# Work Order ID 95926

Parent Item Name: Floor Provisions

**DART SERVICE INSTRUCTION**  
**TO AMEND INSTALLATION INSTRUCTIONS IIN-D350-689 REV. B**  
**AND INSTRUCTIONS FOR CONTINUED AIRWORTHINESS ICA-D350-689 REV. 1**  
REF. TCCA STC: SH02-33  
REF. FAA STC: SR01620NY  
REF. EASA STC: EASA.IM.R.S.01453  
REF. TCA STC: 2005S03-09

**1.0 PURPOSE**

**FIGURE 1: UPDATES TO CROSS SECTIONS F-F AND M-M**

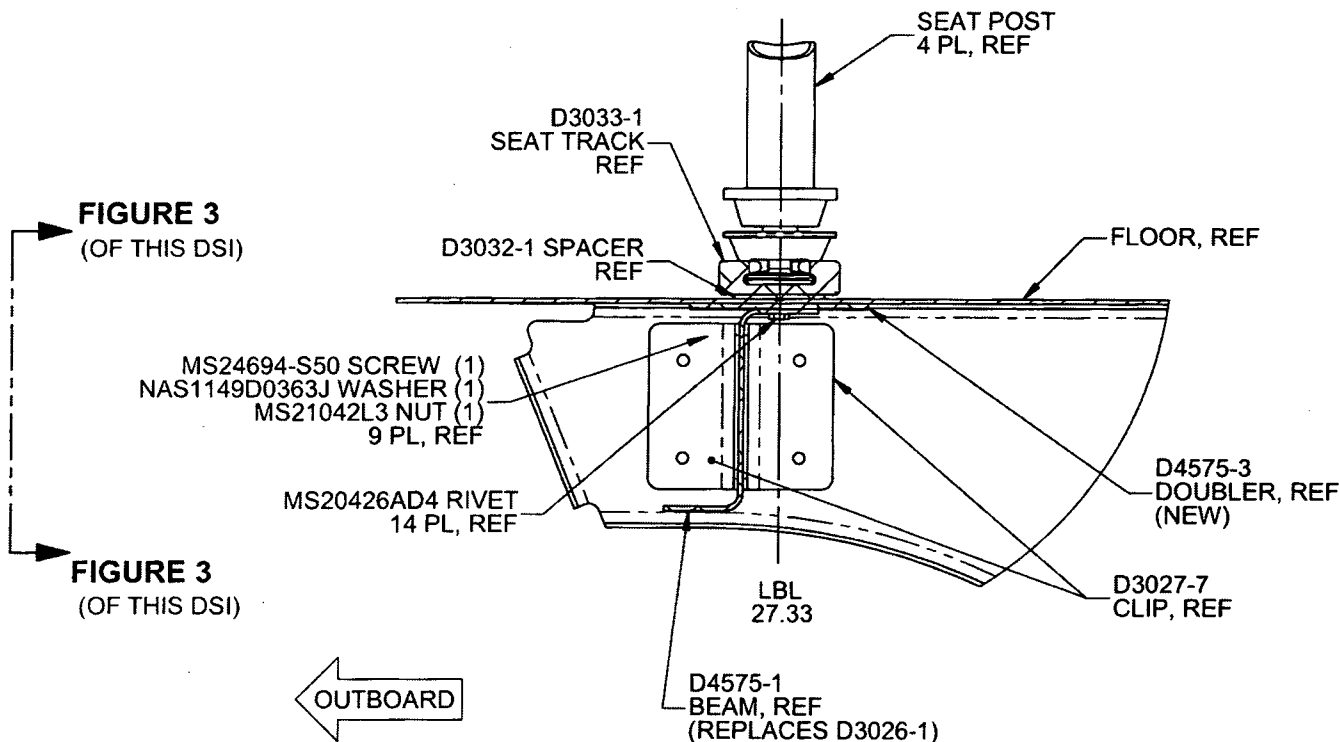
If there is an existing stringer at LBL 27.33, it will need to be removed from that location. Locate D4575-1 Beam, D4575-3 Doubler, and D3032-1 Spacer as shown in Figure 1 of this Service Instruction. Transfer drill existing holes from the aircraft floor to the D4575-1 Beam, D4575-3 Doubler, and D3032-1 Spacer. Ensure 1.0" to 1.5" rivet pitch and add additional holes if required. If there is no existing stringer, locate D4575-1 Beam, D4575-3 Doubler, and D3032-1 Spacer as shown in Figure 1 of this Service Instruction and drill Ø0.128" holes on a 1.0" to 1.5" pitch.

If there is an existing stringer at LBL 27.33, it will need to be removed from that location. Locate D3026-1 Channel as shown in Figure 4 and transfer existing holes from the aircraft floor to the D3026-1 Channel & D3032-1 Spacer. Ensure 1.0" to 1.5" rivet pitch and add additional holes if required. If there is no existing stringer, locate D3026-1 Channel & D3032-1 Spacer as shown in Figure 4 and drill Ø0.128" holes on a 1.0" to 1.5" pitch.

**FIGURE 2: UPDATES TO FIGURE 21 (IIN-D350-689) AND 25-21 (ICA-D350-689)**  
 With reference to Figures 19 and 20 of IIN-D350-689  
 (Figures 25-19 and 25-20 of ICA-D350-689)

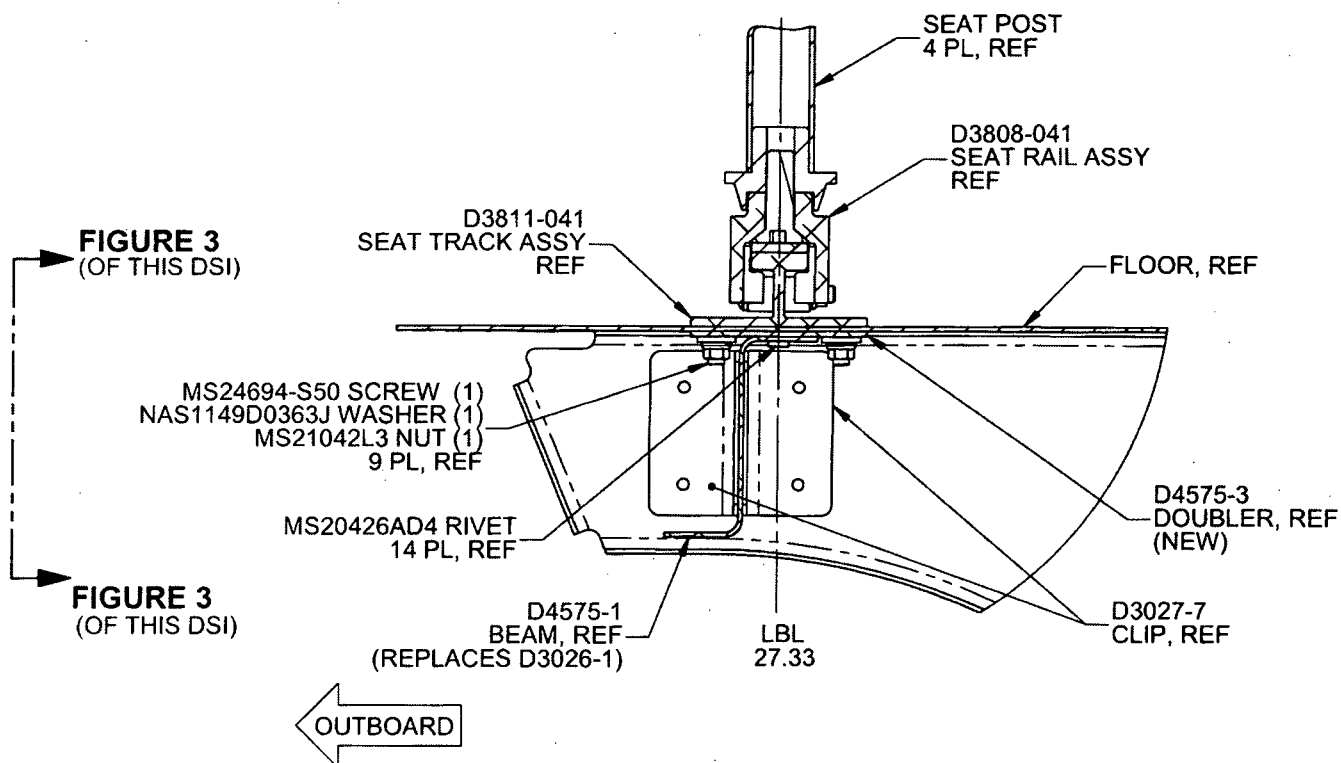
If there is an existing stringer at LBL 27.33, it will need to be removed from that location. Locate D4575-1 Beam and D4575-3 Doubler as shown in Figure 2 of this Service Instruction. Transfer drill existing holes from the aircraft floor to the D4575-1 Beam and D4575-3 Doubler. Ensure 1.0" to 1.5" rivet pitch and add additional holes if required. If there is no existing stringer, locate D4575-1 Beam and D4575-3 Doubler as shown in Figure 1 of this Service Instruction and drill Ø0.128" holes on a 1.0" to 1.5" pitch.

If there is an existing stringer at LBL 27.33, it will need to be removed from that location. Locate D3026-1 Channel as shown in Figure 4 and transfer existing holes from the aircraft floor to the D3026-1 Channel. Ensure 1.0" to 1.5" rivet pitch and add additional holes if required. If there is no existing stringer, locate D3026-1 Channel as shown in Figure 4 and drill Ø0.128" holes on a 1.0" to 1.5" pitch.

**FIGURE 3: RELIEFS ON D4575-1/-3**  
(ONLY D4575-1/-3 SHOWN FOR CLARITY)  
VIEW LOOKING INBOARD

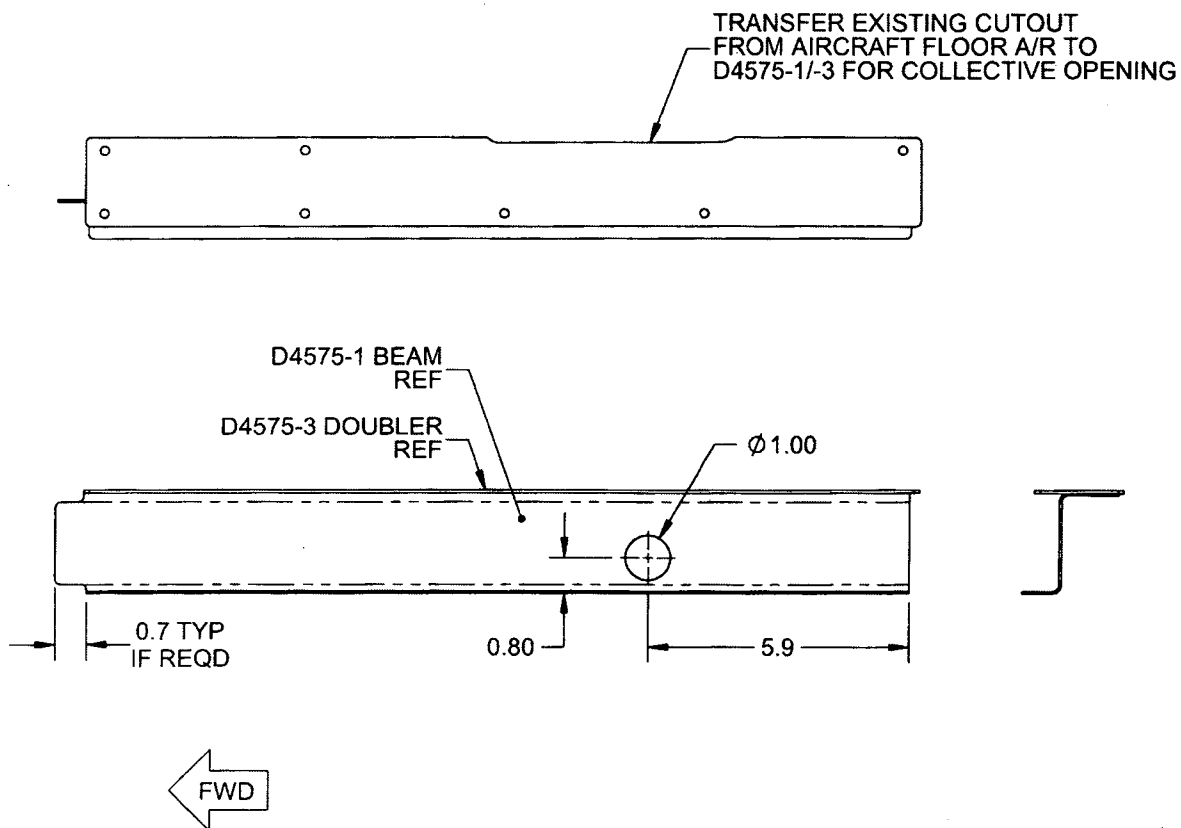
**Note:** Drill a Ø1.00" (Ø25.4 mm) hole in the D4575-1 Beam to clear extension tube of collective and cutout as required for clearance of collective opening and fwd bulkhead as shown in Figure 3 of this Service Instruction.

**Note:** Drill a Ø1.00" (Ø25.4 mm) hole in the D4575-1 Beam to clear extension tube of collective and cutout as required for clearance of collective opening and fwd bulkhead as shown in Figure 3 of this Service Instruction.
